UNITED STATES
DEPARTMENT OF THE INTERIOR
BUREAU OF LAND MANAGEMENT
Sundry Notices and Reports on Wells

8. **Well Name & Number**
Cuba Mesa 35-1

PLUG & ABANDONMENT PROCEDURE

IN REPLY REFER TO
3162.3-1 (017)

Proposed P&A

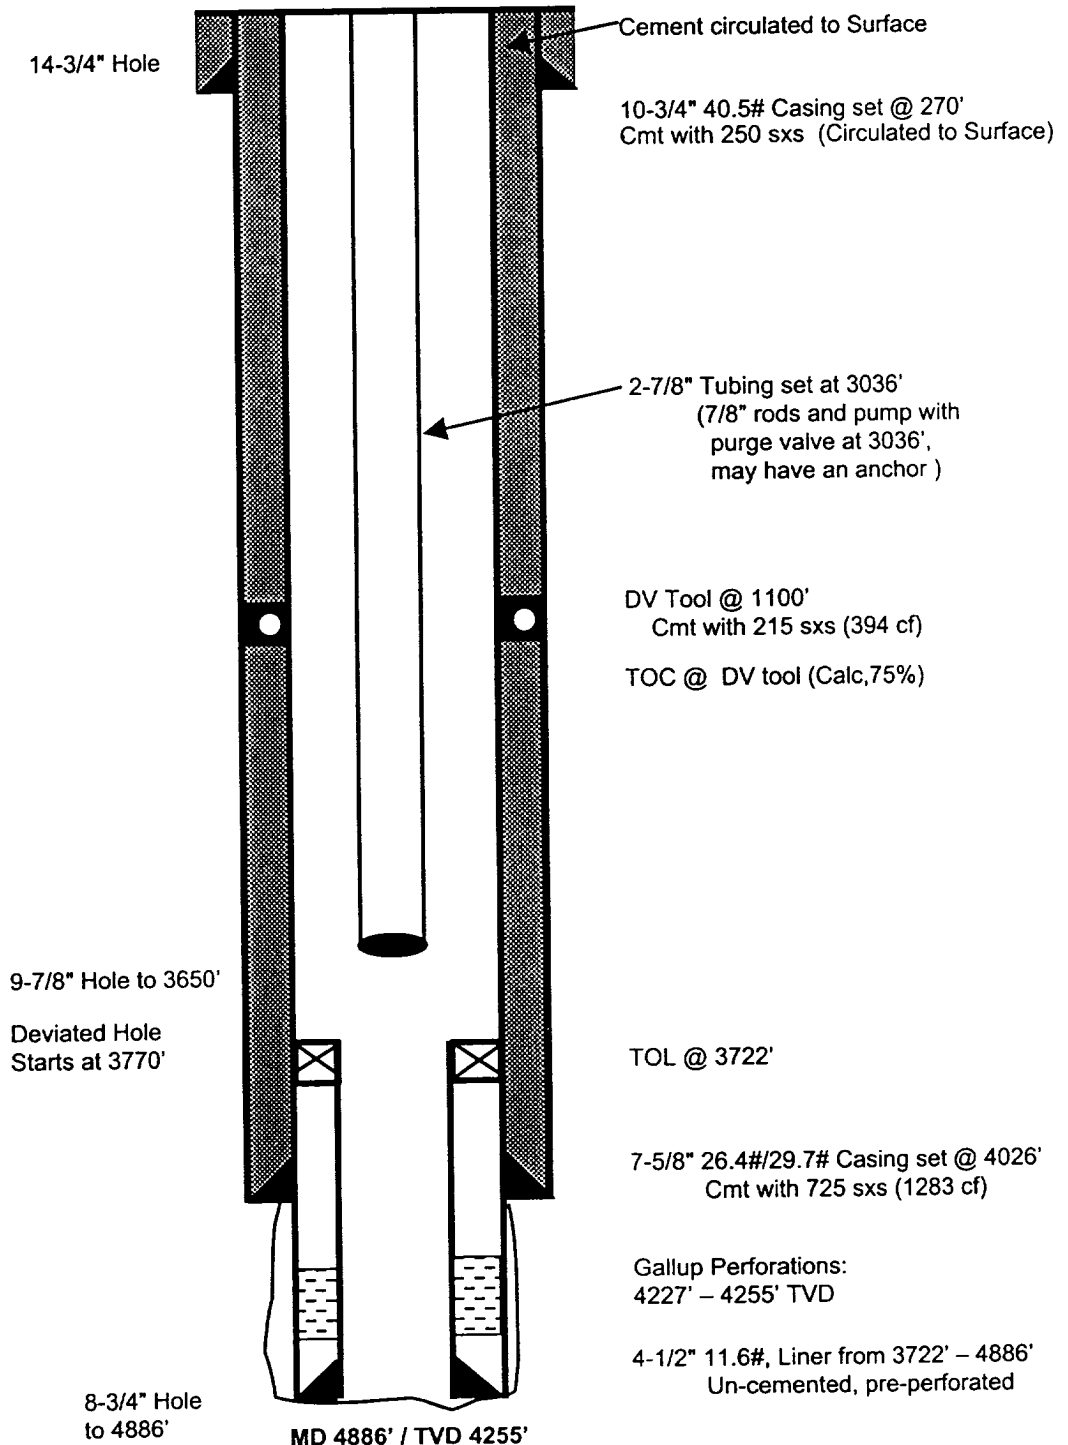
Plug #5: 50' - Surface
Cement with 12 sxs

Plug #1: 3672' - 3612'
Cement with 22 sxs

1. Plugging operations authorized are subject to the "General Requirements for Permanent Abandonment of Wells on Federal and Indian Leases."
2. Blowout prevention equipment is required.
3. Plug No. 1 changed to 34 sacks, 3672 - 3572',
Plug No. 5 changed to 22 sacks, 100' - surface
4. Santa Fe National Forest Surface Restoration Requirements are attached.
Contact info SFNF - Larry Gore 505.289.3265
5. ROW NMNM 87586 will need to be assigned pending determination of assignee.*
